**IN THE DRAWINGS:**

## REMARKS

FIG. 3

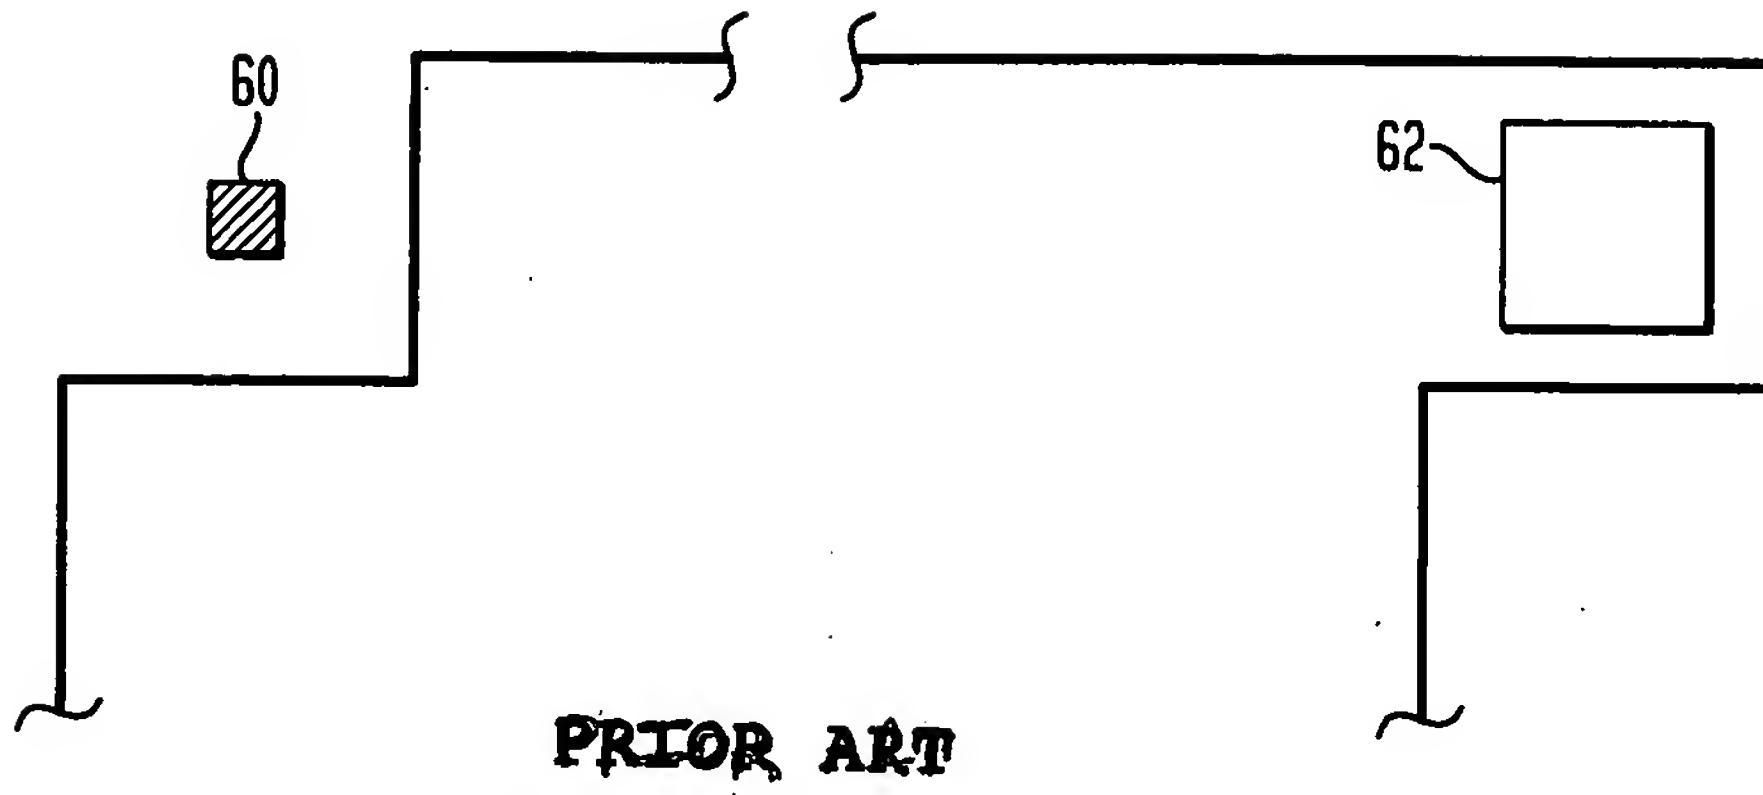
The Examiner also objected to the drawings. Specifically, the Examiner noted that there is an unlabelled item in Figure 1, and that Figures 3 and 4 should be designated as "Prior art." The Examiner required correction of the drawings.

With respect to the drawings, Figure 1 is being amended to add a reference number "17" to reference the previously unlabelled item, which is an exposure apparatus or system. The specification is also being amended to specifically identify the exposure apparatus and to include this reference number. This exposure apparatus is known in the art and is represented in Figure 1 in a standard manner. Those of ordinary skill in the art would readily recognize that this item is an exposure apparatus, and thus expressly identifying the item as such in the specification is not new matter. Also, Figures 3 and 4 are being labeled "Prior Art." It is believed that these changes overcome all of the Examiner's objections to the drawings, and the Examiner is thus asked to reconsider and to withdraw these objections.
